April 8, 2022

Subject: Petition for Reconsideration to Docket No. NHTSA–2022–0013; RIN 2127-AL83; Fed. Reg. Vol. 87, No. 35, February 22, 2022

**Figure 2**

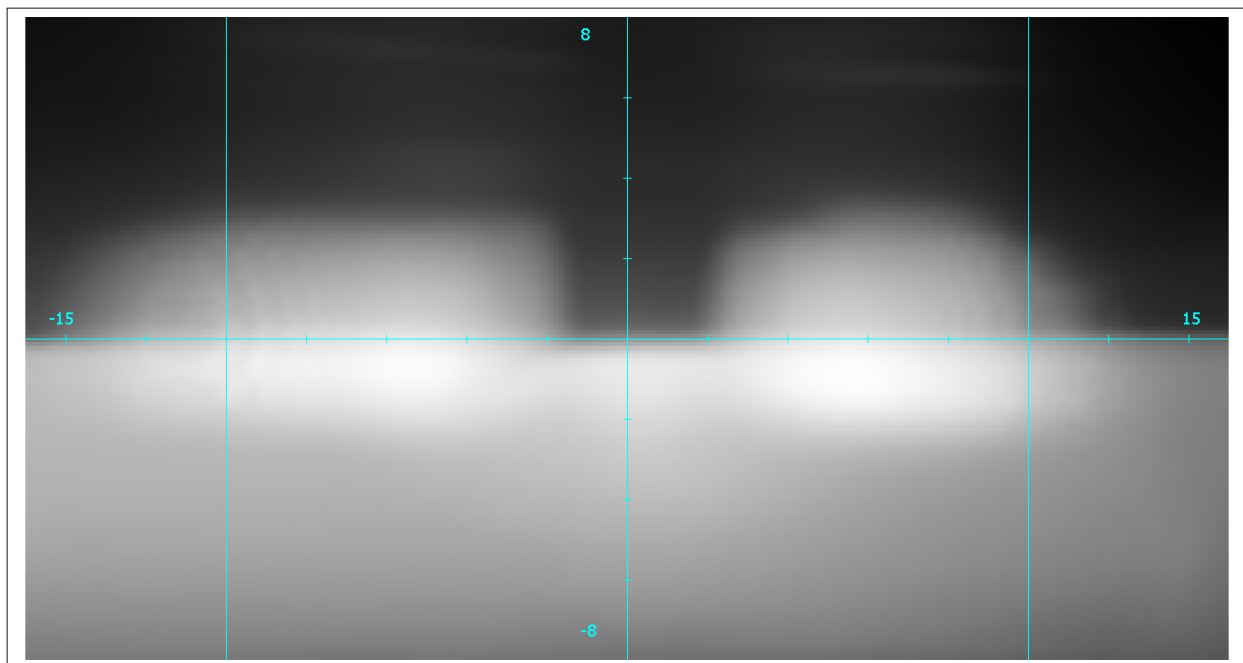
As can be seen in Figure 2 the transition from the area of reduced intensity to the area of unreduced intensity is not instantaneous. To fully transition from the edge of the area of reduced intensity to an area of full intensity in the upper beam portion of the ADB

**Figure 3**

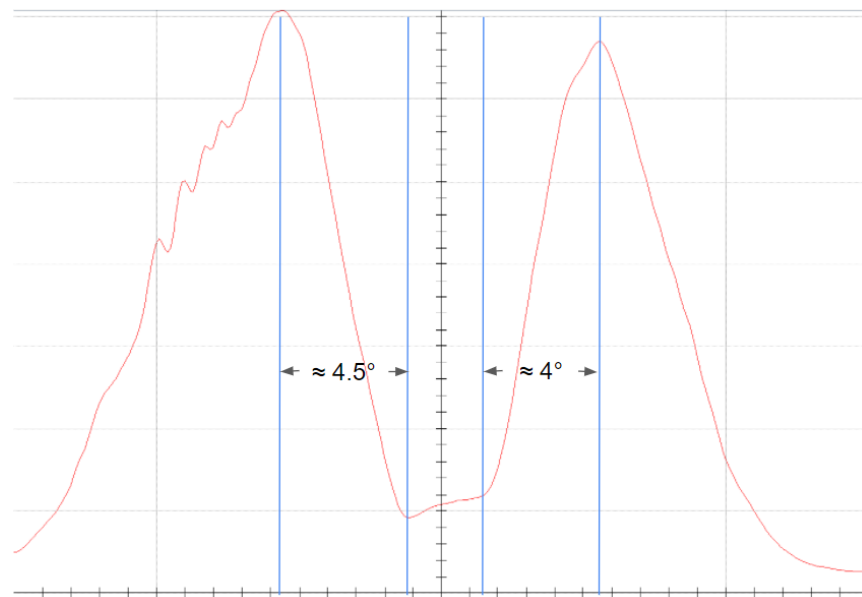
beam takes at least  $4^\circ$  as shown in Figure 3. This is a light intensity scan of the H-H line from the same lamp shown in Figure 2.

As a result of the above the current requirement of  $1^\circ$  maximum transition zones will result in much larger areas of reduced intensity in order to meet the minimum requirements of the upper beam beam test points in the areas of unreduced intensity. The transition zones would need to be placed so that the closest upper beam test point with minimum values is included inside of the transition zone if these test points do not fall inside the area of reduced intensity.

criteria for a petition of reconsideration to be granted. Our recommendation would be to change the transition zone maximum width to 4° and/or remove the requirement to meet the upper beam minimums in the area of unreduced intensity while keeping the requirement that no upper beam maximums can be exceeded in this same area. Without these changes approximately 88% of our ADB systems currently on the road in other regulatory markets would not meet the FMVSS-108 requirements and would require significant, and in our opinion unnecessary, design changes to make them compliant.

**Figure 4**

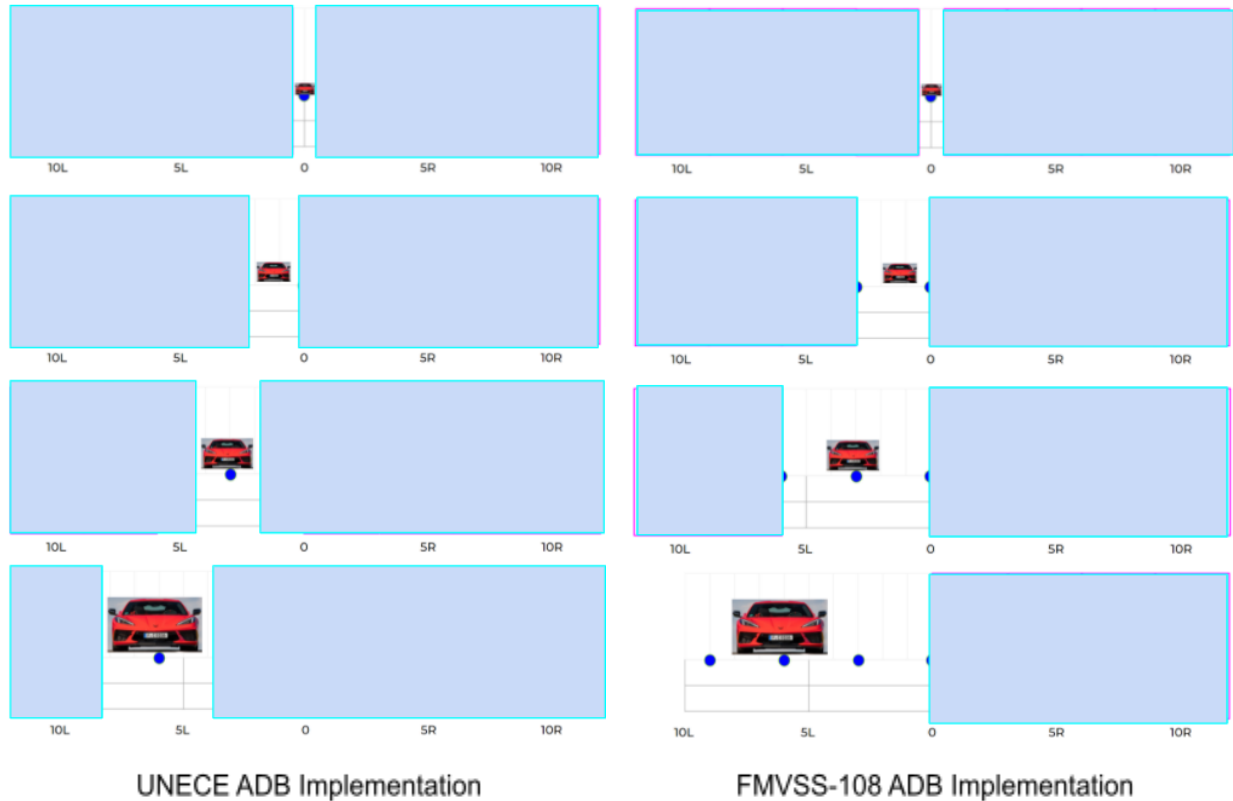
As is illustrated the UNECE implementation results in narrower areas of reduced intensity that closely follow the width of the oncoming vehicle. This results in the full benefit of the ADB system being utilized since as much light as possible is available in the resulting beam pattern without generating any glare toward the oncoming vehicle.

Due to the limitation of the 1° transition zone and having to meet the upper beam photometric requirements throughout the entire area of unreduced intensity the area of reduced intensity is much larger for FMVSS-108 ADB implementation. This results in minimizing the added safety benefit of ADB.

Figure 5

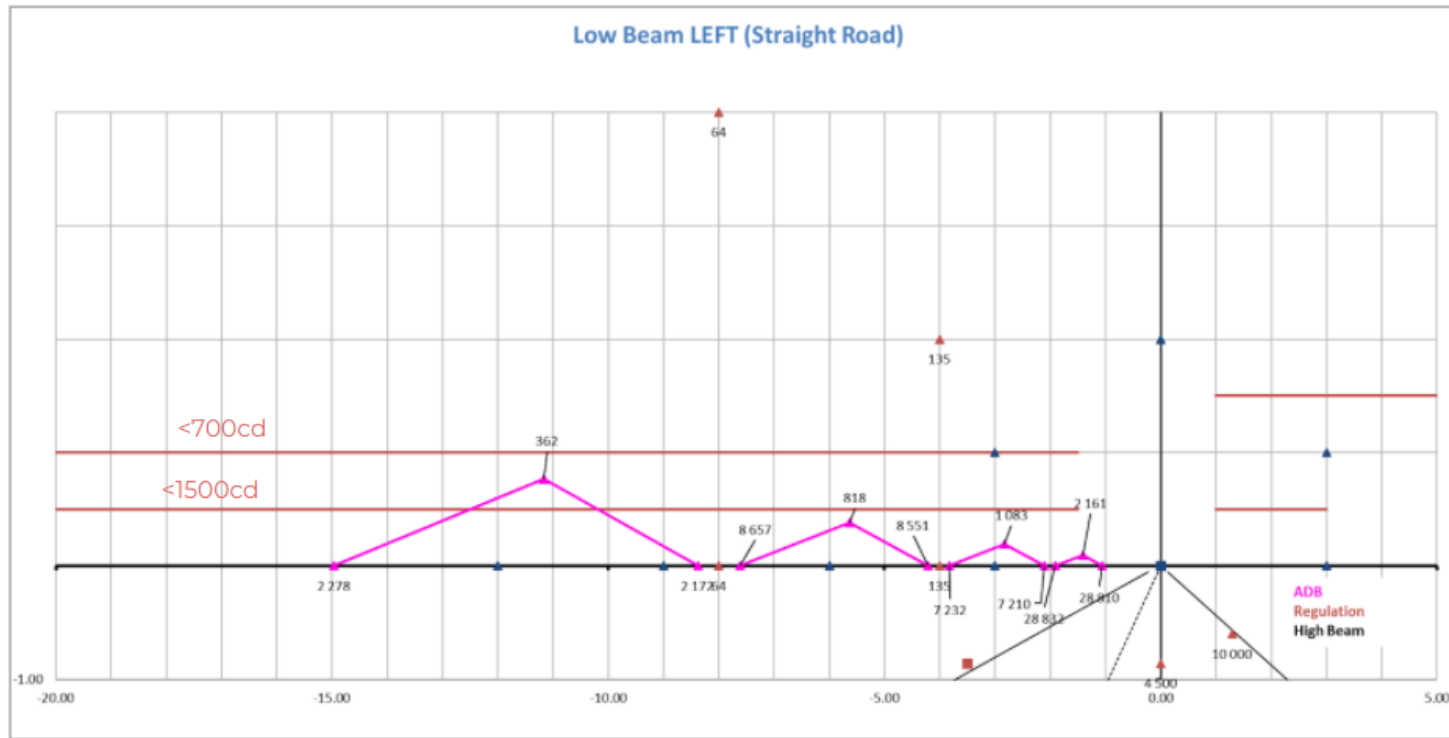
Following are three separate analyses completed for the same direction driving scenarios. Figure 5 shows a 750 mm headlamp mounting height, Figure 6 shows a 900 mm mounting height and Figure 7 shows a 1160 mm mounting height. All three figures show the glare requirements at 15m, 30m, 60m and 120m for the driver and passenger outside rearview mirrors and the vehicle driver's eyes photometers on the specified test fixture. Our internal analysis showed these photometers to be the more critical to monitor to ensure overall compliance to the glare requirements. These grouped requirements are shown as small triangles connected by a solid line. The glare requirements shown are the result of dividing the calculated system requirements by 2 to account for each side of the vehicle. These figures show what would be the requirements for the left side headlamp. The figures also show both the lower and upper beam photometric requirements.

As can be seen in these figures as the mounting height of the headlamps increases the glare requirements become more difficult if not impossible to pass. The ADB glare requirements begin to conflict with the lower beam photometric requirements. Per the preamble of the final rule NHTSA acknowledges that there may be issues in complying with the glare requirements but also suggests there may be ways to deal with this including redesigning the lower beam photometric output or as per footnote 100 incorporating dynamic vertical aiming into the headlamp. We do not believe that redesigning the lower beam photometric output would solve this issue. While incorporating dynamic vertical aim may aid in meeting the ADB glare requirements, this would sacrifice the ability to have the benefit of the visibility provided by a traditional lower beam in the area of reduced intensity, as is stated in the preamble as well.

Valeo believes that the issues discussed above regarding the ADB road test glare requirements meet all three criteria for a petition of reconsideration to be granted. Our recommendation would be to change these glare requirements from mandated fixed values to values that are calculated based on the headlamps being tested. This would include doing a baseline glare measurement of the vehicle’s standard lower beams using the mandated test fixtures and driving scenarios and then repeating the test scenarios with the ADB system activated. The measured glare values with the ADB system activated could not exceed the baseline measurements by more than 25%. This is essentially the same as what is currently described in SAE J3069.

Figure 8

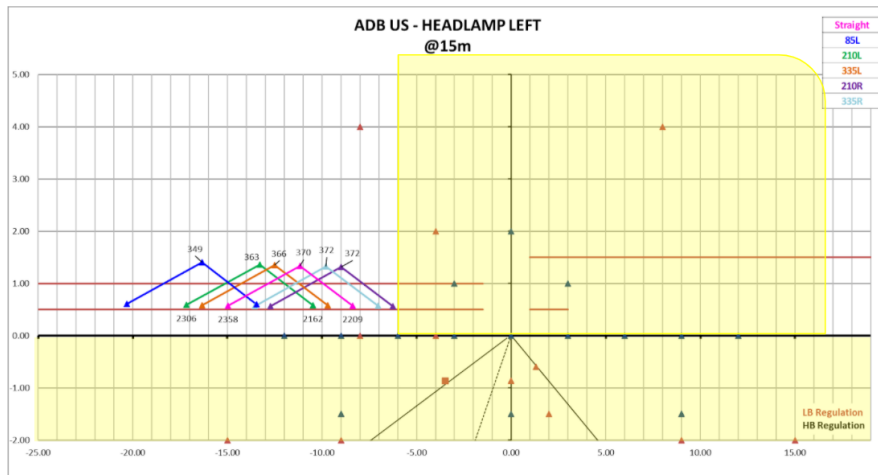
Based on the above Valeo feels this requirement is unreasonable and not practicable. Our recommendation would be to define specific laboratory testing configurations that parallel the vehicle road test scenarios. This would be similar to what is done in the UNECE regulations. In our proposal only lower beam photometric test points in the area of reduced intensity and the upper beam H-V test point (if applicable) in the area of unreduced intensity would be checked. We believe that eleven testing set-ups could be defined for each hand of lamp that would cover most if not all of the possible road test scenarios. It could then be inferred that if the requirements are met using these eleven set-ups then all other possible ADB configurations would be compliant.

15m - Figure 8

lower beam test points  
 4U-8L  
 1U-6L to L  
 0.5U - 6L to L

upper beam test points  
 H-V
